Project Name | BCWD Permit 24-01 Take 5 Oil Change

Regarding | Permit Application No. 24-01 Engineer's Report

Recommendation: Consider variance request and otherwise Approve with Conditions

Figure 2: Take 5 Oil Change Parcel and Utility Plan

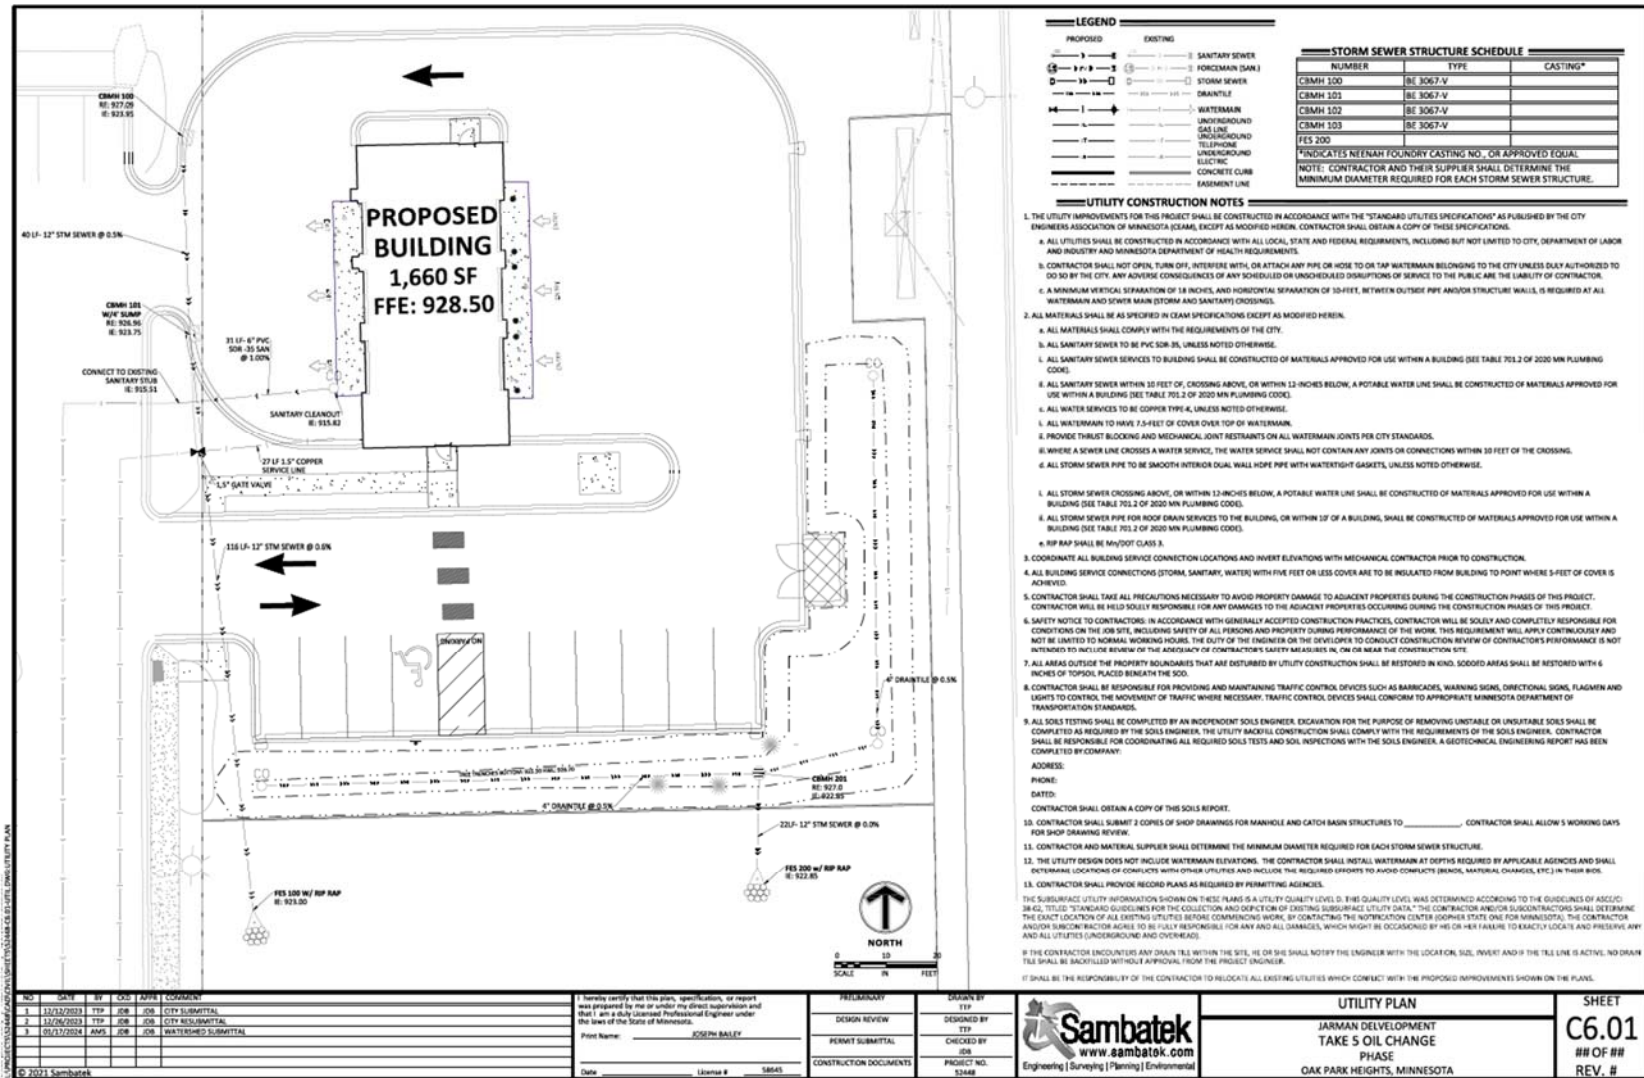
Proposed Conditions: The project site impervious will increase from 2.76 acres to 3.10 acres, an increase of 12 percent. The proposed Take 5 Oil Change will create 0.34 acres of impervious surface and the remaining 0.19 acres of the parcel will consist of pervious surfaces including turf grass and a tree trench stormwater management system. The oil change development will include a drive-thru building, bituminous paved parking lot, concrete curb and gutter, concrete walk, and stormwater management system.

The majority of the stormwater generated from this project will be treated by the tree trench that will provide volume control through evapotranspiration and interception, rate control, and water quality treatment. The site is located within a Drinking Water Supply Management Area classified as having high vulnerability (Minnesota Department of Health Source Water Protection Map Viewer). The site is not, however, in an Emergency Response Area. The state Construction Stormwater General Permit precludes the use of stormwater infiltration in this setting unless a regulated Municipal Separate Storm Sewer System permittee (the City of Oak Park Heights in this case) performs or approves an engineering review sufficient to provide a functioning treatment system and to prevent adverse impacts to groundwater. The City of Oak Park Heights has neither performed nor approved such a review.

Figure 4: Existing site drainage for Outlot A (Take 5 Oil Change).

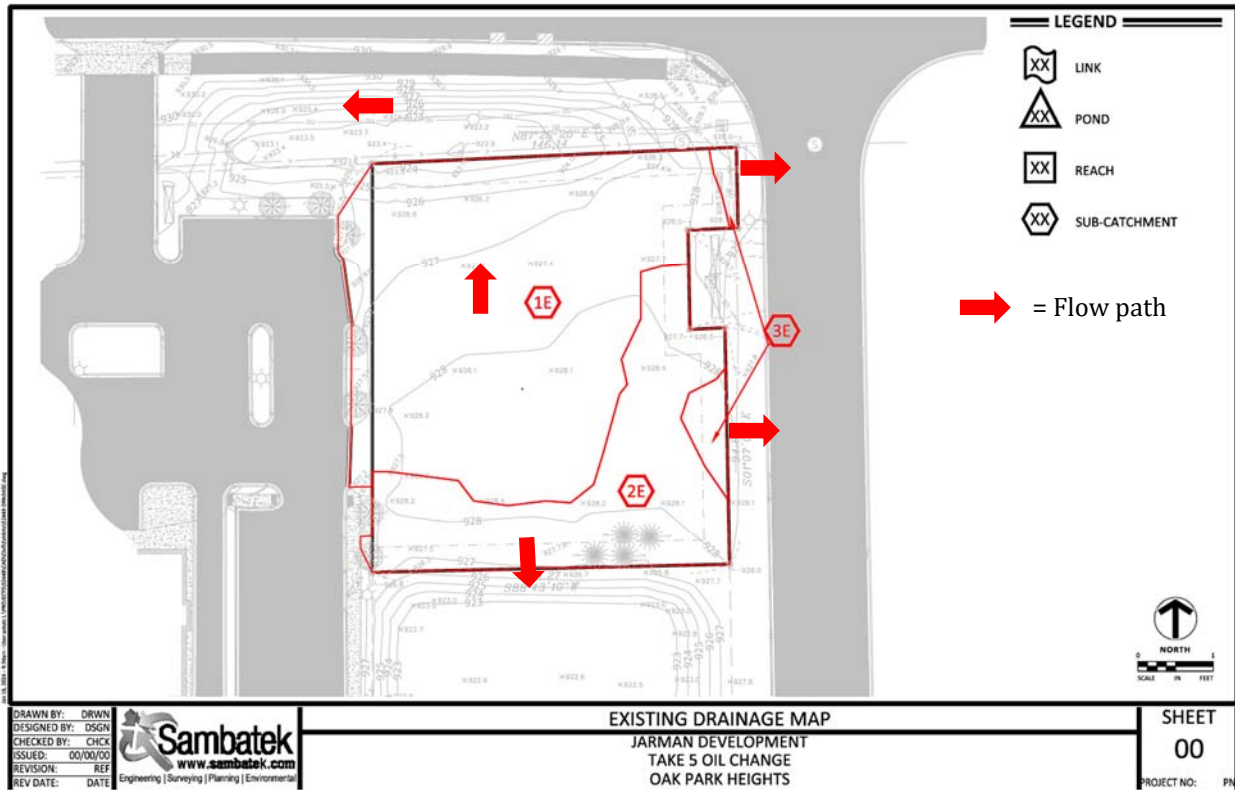
Existing drainage from the portion of the site that is being disturbed (Outlot A) consists of three subcatchment areas: 1E, 2E, and 3E (Figure 4). The three subcatchments discharge to three discharge points labeled North, South, and East (Figure 3Figure 4). The subcatchment areas are 0.37 acres, 0.17 acres, and 0.02 acres respectively. Under existing conditions, the stormwater runoff from subcatchment 1E sheet flows across turf grass discharging to an existing drainage swale located to the north of the property along 60th Street North which routes stormwater runoff to Menard's Pond. Subcatchment 2E sheet flows to the south across turf grass discharging to an existing filtration basin facility constructed with the Brackey 4th Addition. The filtration basin outlet is a storm sewer pipe that discharges into Menards Pond, and this is the regulated discharge point at the site boundary. As this storm sewer flows west it receives runoff from the existing Goodwill building and parking lot. Subcatchment 3E sheet flows to the east across turf grass discharging to Krueger Lane and the storm sewer which routes stormwater runoff to Menards Pond. Additional discharge points from the Retail Store parcel (north to the existing swale or via separate storm sewer to Menards Pond) are not considered as there are no changes from existing to proposed conditions for these areas.

Figure 5: Proposed site drainage for Outlot A (Take 5 Oil Change).

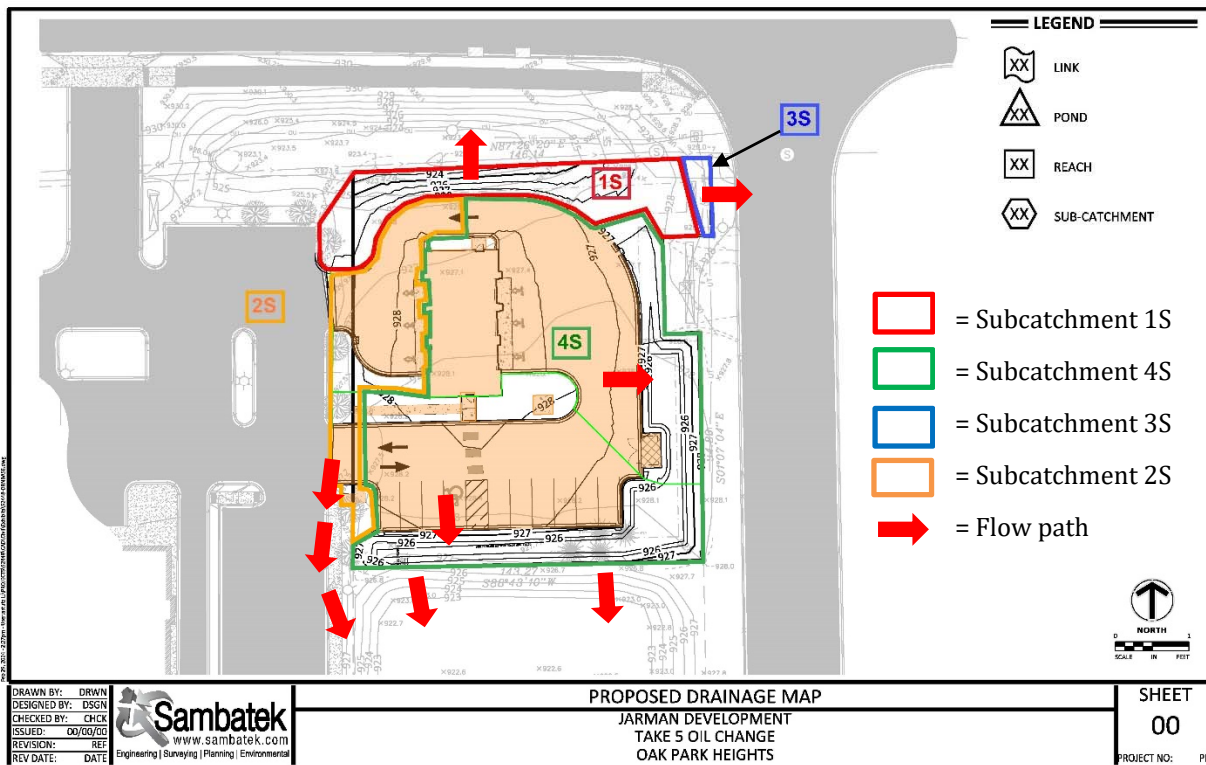
Under proposed conditions, there will be four drainage areas: 1S, 2S, 3S, and 4S. The four subcatchments will continue to discharge to the same three points as in the existing conditions: North, South, and East (Figure 5). Stormwater in subcatchment 1S will sheet flow to the north over turf grass to the existing drainage swale along 60th Street North and ultimately to Menard's Pond. Subcatchment 2S will sheet flow over bituminous pavement before being collected in catch basins located along the curb and routed via storm sewer to the Brackey 4th Addition filtration basin to the south of the property. Subcatchment 3S will sheet flow east over turf grass to Krueger Lane where it is picked up by an existing catch basin and storm sewer and is routed to Menard's Pond. Stormwater in subcatchment 4S will sheet flow over bituminous pavement before ending up in the tree trench system. Any stormwater runoff that isn't taken up by the trees and/or vegetation will be collected by drain tile and routed to the south into the Brackey 4th Addition filtration basin. All proposed new impervious surface is within subcatchment 2S and 4S.
